PROJECT Turkevi Center
LOCATION Multi Firs
 821 FIRST AVENUE
 NEW YORK, NY
ARCHITECT PERKINS EASTMAN
 115 5th AVENUE, NEW YORK NY
CONTRACTOR TISHMAN CONSTRUCTION
 100 PARK AVENUE, NEW YORK NY

TITLE: Auditorium
ITEM NO.: 11, 11.01, 11.02, 11.03, 11.04, 11.05, 11.07, 11.08, 11.09, 11.10, 11.11
DESC.: PLAN
DESC.: AUDITORIUM SB1-24, VESTIBULE SB1-20 & SB1-17, WAITING ROOM SB1-22
By: PD **Scale:** As Noted **Job No.:** **Dwg. No.:** 11-01
Status: IN SUBMITTAL REVIEW **Date:** 2019-01-21

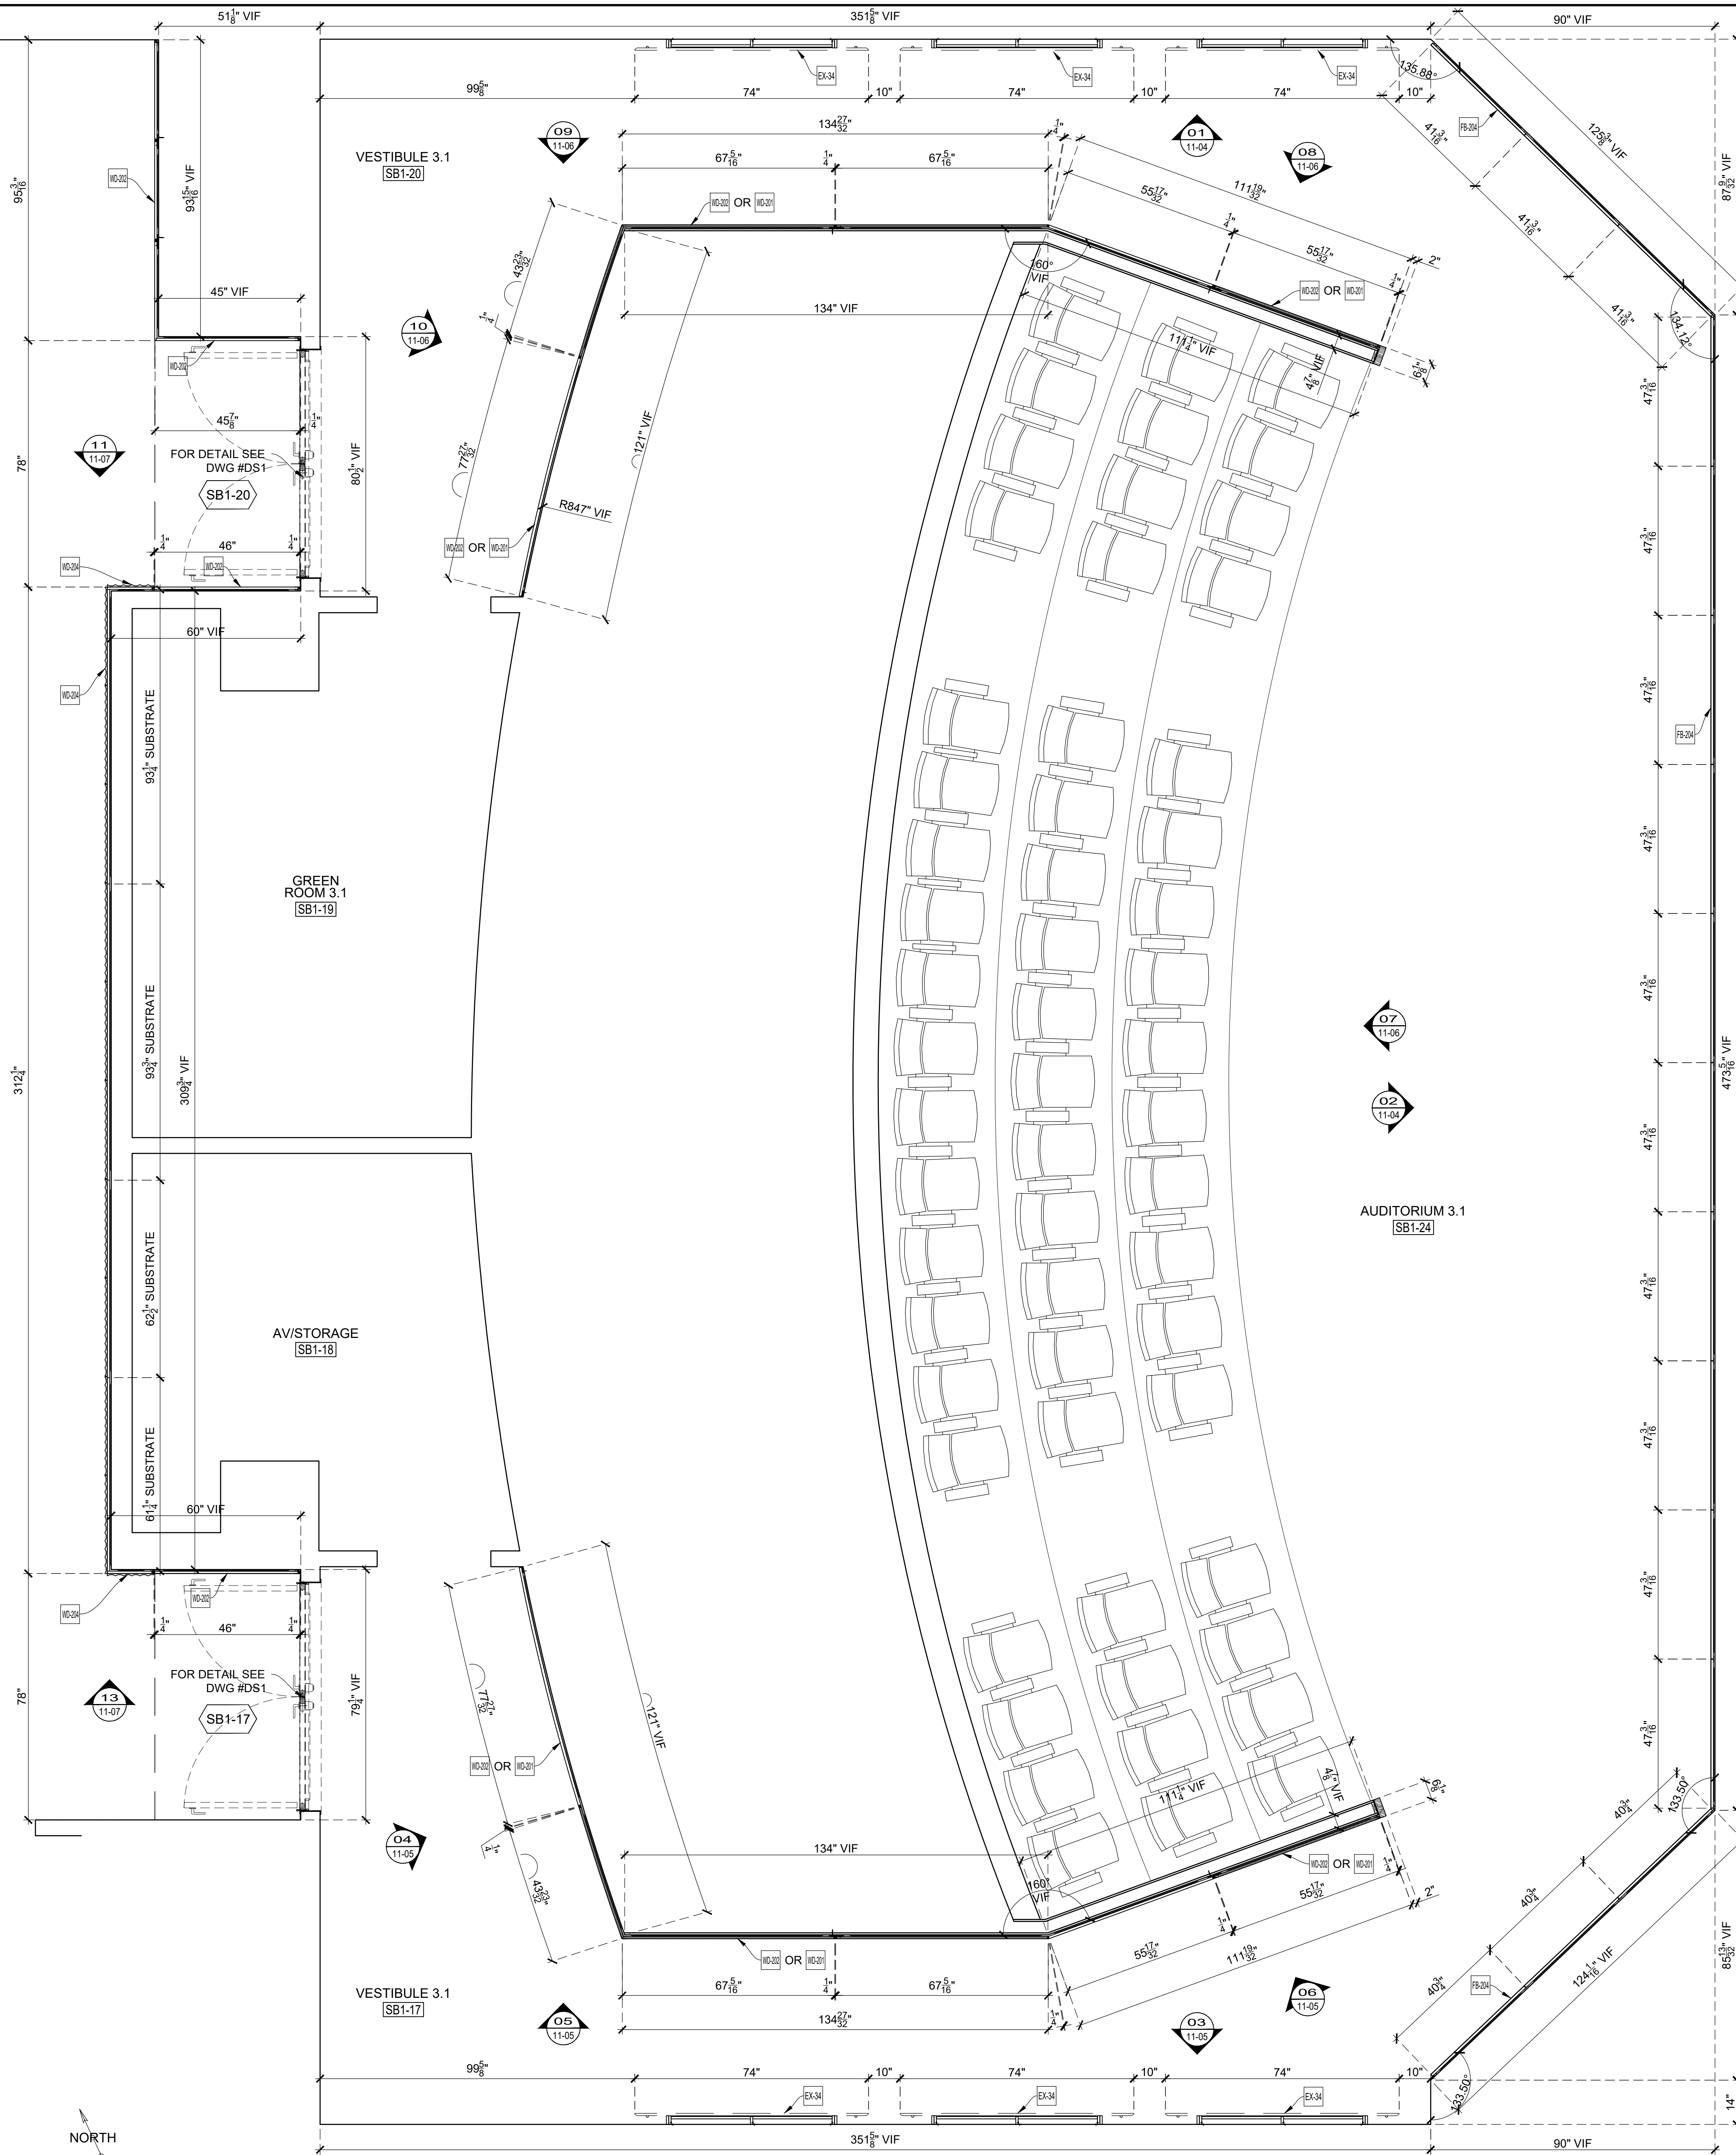
ARCHITECT NOTE:
PLEASE PROVIDE SPECIFICATION AND CUTSHEET FOR COORDINATION

ELEVATION
 11-06
 SCALE: 1/2" = 1'-0"
 Archt Ref.: 2/A-603.00 (SIM)

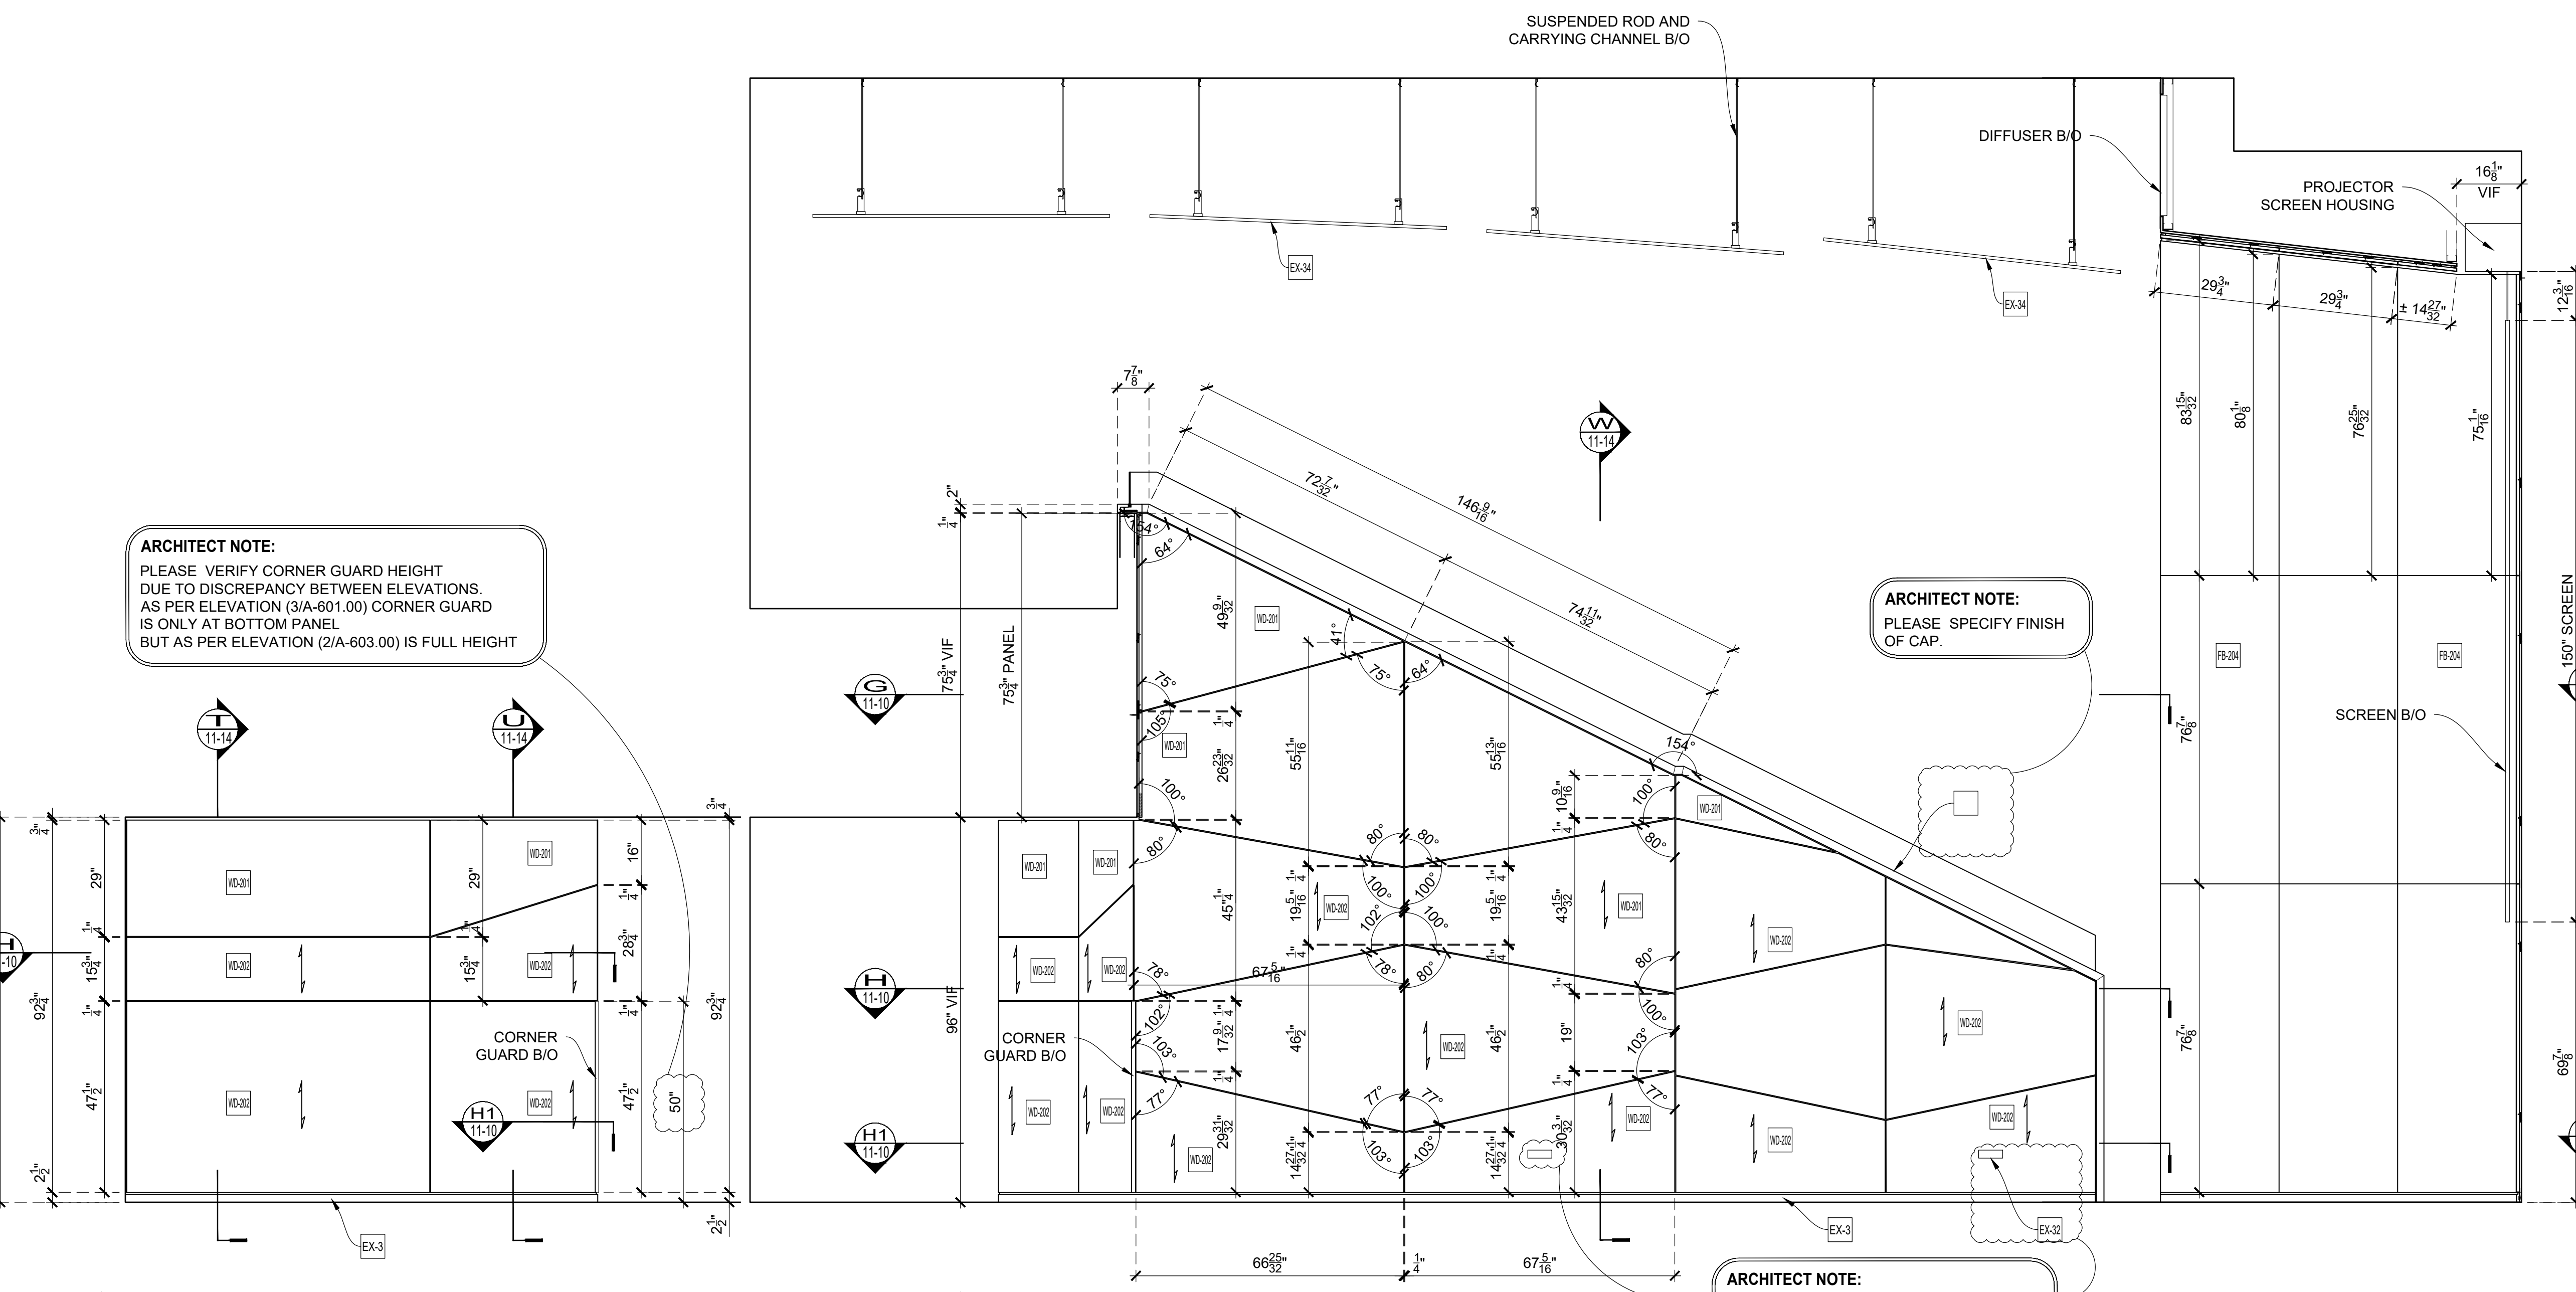
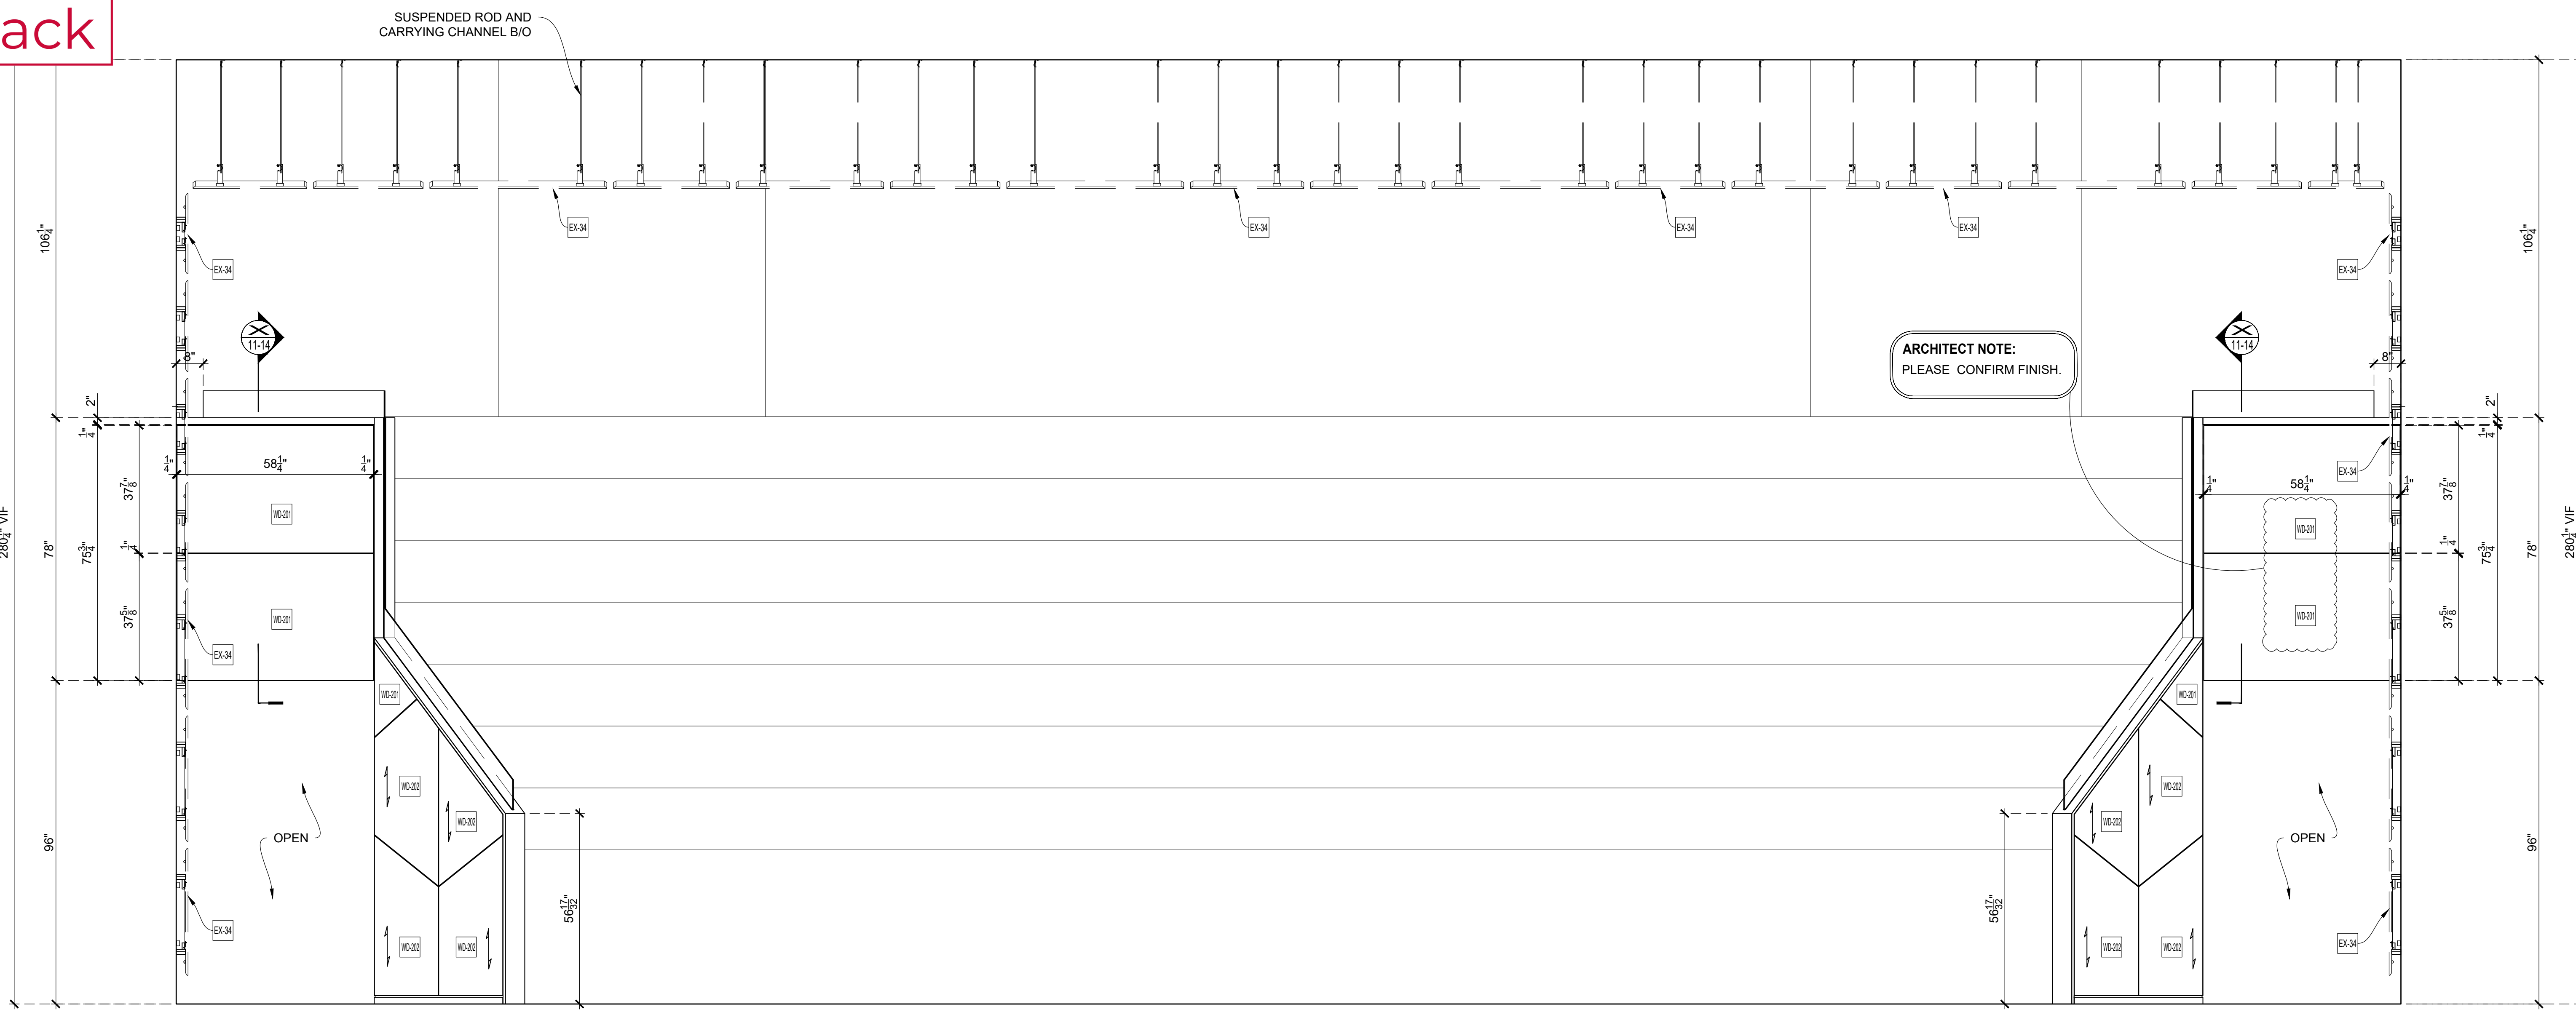
ARCHITECT NOTE:
 PLEASE VERIFY CORNER GUARD HEIGHT
 DUE TO DISCREPANCY BETWEEN ELEVATIONS.
 AS PER ELEVATION (3/A-601.00) CORNER GUARD
 IS ONLY AT BOTTOM PANEL
 BUT AS PER ELEVATION (2/A-603.00) IS FULL HEIGHT

ARCHITECT NOTE:
 PLEASE SPECIFY FINISH
 OF CAP.

ARCHITECT NOTE:
 SPECIFY LOCATION OF LIGHT FIXTURES
